SUBJECT: ADMINISTRATIVE ORGANIZATIONAL CHANGES

Re: Oyster Creek Nuclear Generating Station

AMENDMENT TO THE AMENDED PROVISIONAL OPERATING LICENSE

Amendment No. 69
License No. DPR-16

FIGURE 6.2.1
ORGANIZATION CHART
GPU NUCLEAR CORPORATION

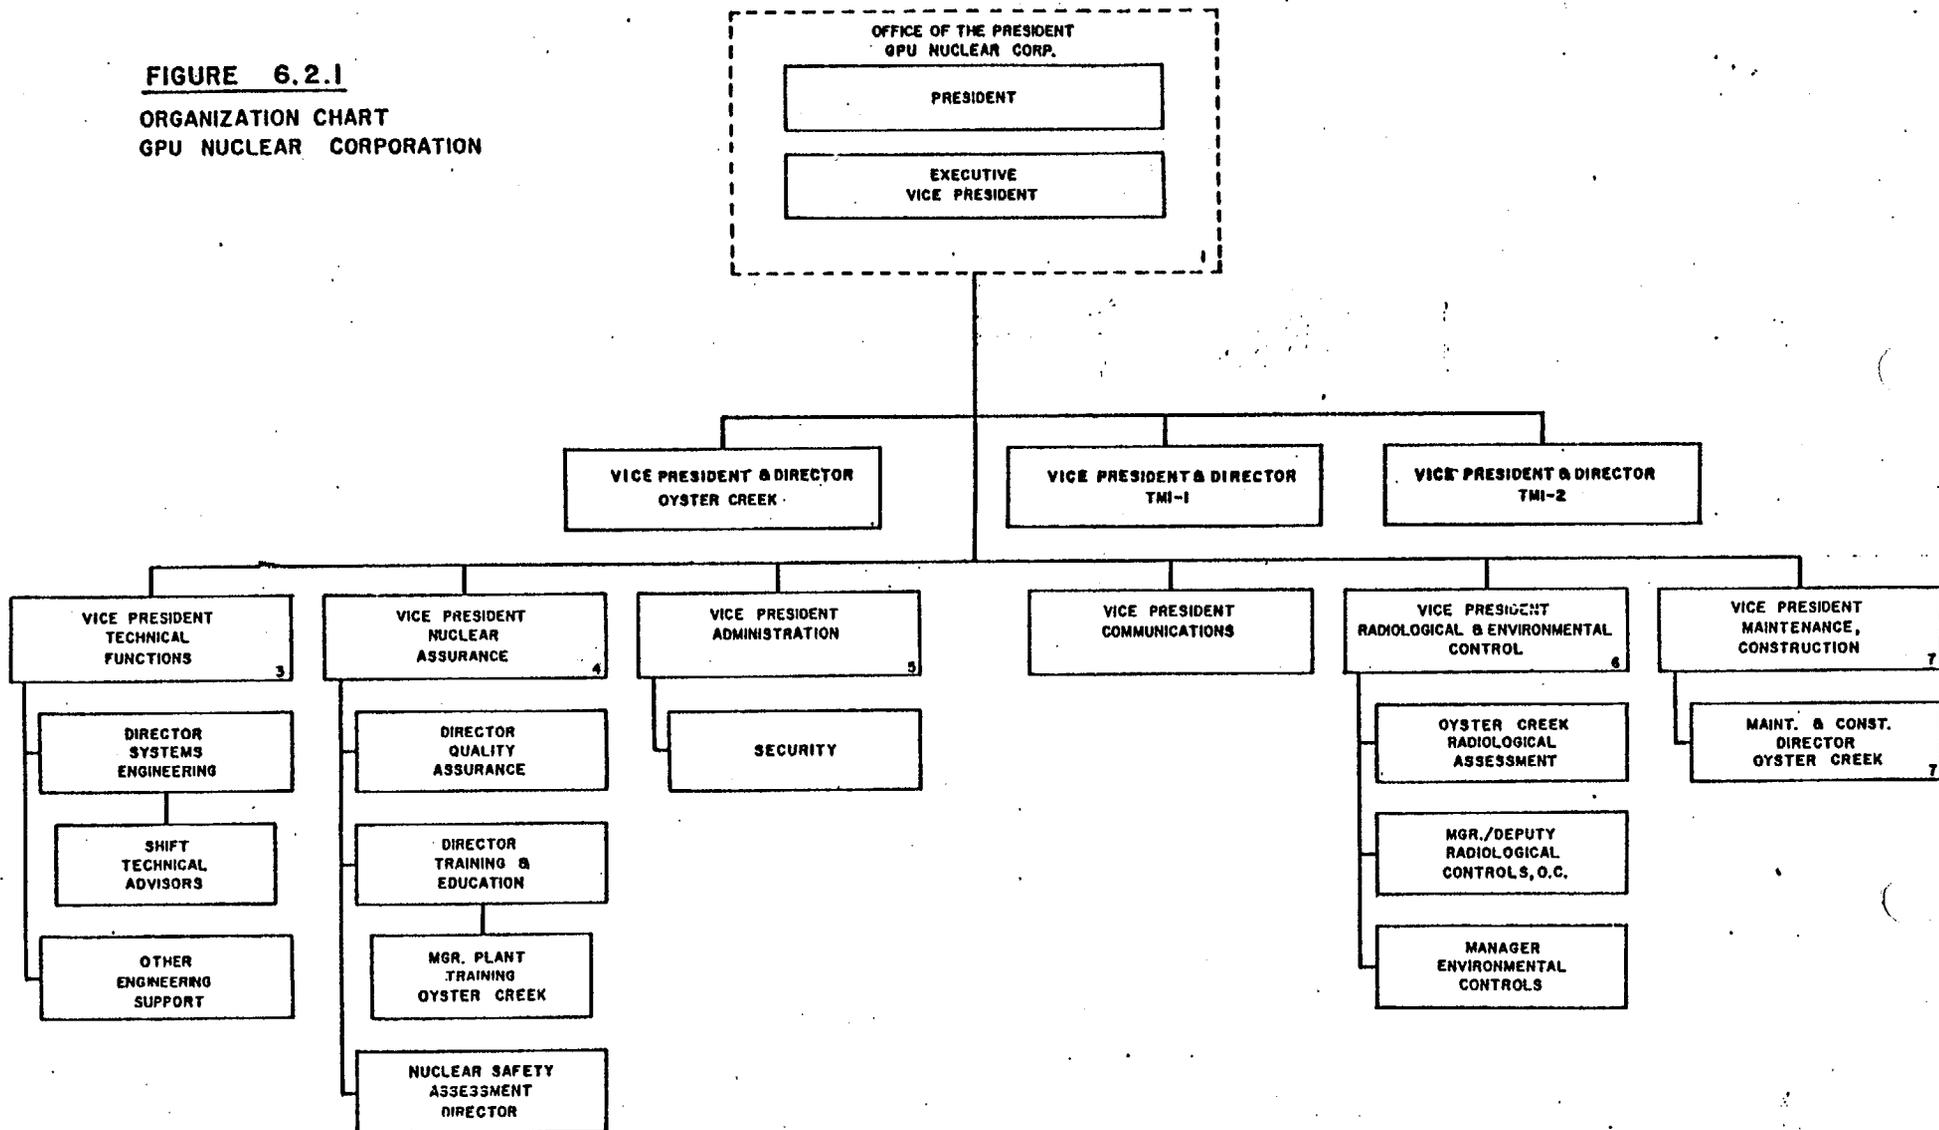
The GPU proposed Technical Specification changes would revise the administrative controls section. Specifically, the organization for GPU Nuclear Corporation, figure 6.2.2, has been changed to add the position of Maintenance and Construction Director Oyster Creek. This is an update of figure 6.2.2 to be consistent with a change in the maintenance organization which was approved by amendment 68 dated September 28, 1983.

The organization for GPU Nuclear Corporation for management and technical support shall be functionally as shown on Figure 6.2.1.

5. The conduct of all Oyster Creek modifications, repairs and construction activities will be the responsibility of the Maintenance and Construction Director - Oyster Creek who will report to the Vice President Maintenance and Construction.
